REVISION 1
TO
KWM/HF-380 SERVICE BULLETIN NO 7

KWM-380 TRANSCEIVER (622-5093-001, -101)
HF-380 TRANSCEIVER (622-3580-001, -101)
CONTROL CARD A8 (638-6929-001, -002)

SERVICE BULLETIN NO 7**PREVENT EXCESSIVE EMI (RCVR BIRDIES) AND
ELIMINATE ELECTRONIC TUNING BACKLASH**

P/O Control Card A8
Figure 1

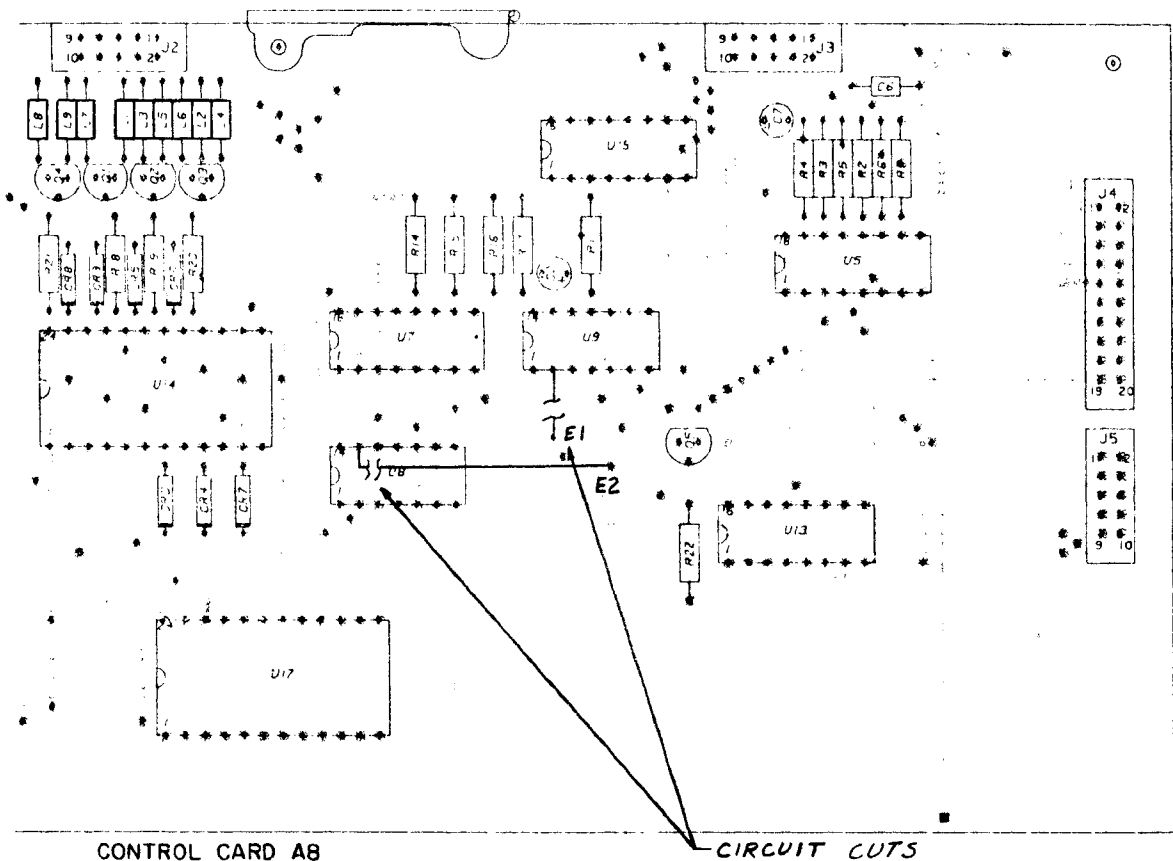
- E. Remove 100- μ H coils L1 through L9 and replace them with 560- μ H coils (240-2723-050).
- F. Cut the circuit trace from U9-2 to E1.
- G. Cut the circuit trace from U8-13 to E2.
- H. On the bottom of the card, install a jumper wire (422-2400-020) from E1 to U9-4.
- I. On the bottom of the card, install a jumper wire (422-2400-020) from E2 to U8-12.
- J. Install two cable clamps (150-0873-010) in the synthesizer compartment as shown in figure 2.
- K. Route the two cables on the back of the synthesizer assembly through the cable clamps and out the end of the card cage. This will hold the cables away from the circuit card components.
- L. Reassemble the transceiver in the reverse order of disassembly.

P/O Control Cable A8, Schematic Diagram
Figure 3

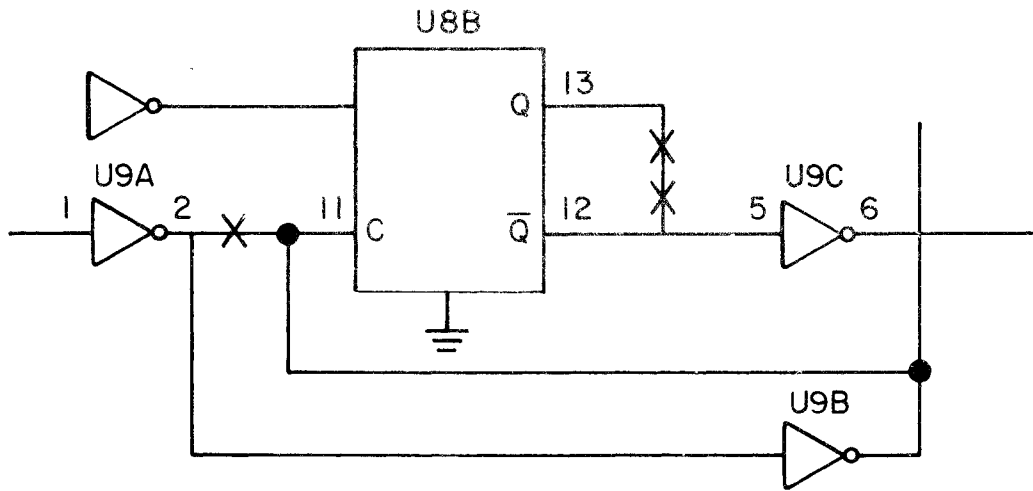
NOTE: Refer to the control card A8 instructions, CPN 523-0770685, figure 5, located in the back of the KWM-380/HF-380 service manuals and to figure 1 of this bulletin while performing steps E through I. Refer to figure 2 while performing steps J and K. Figure 3 shows the changes in steps F through I schematically.
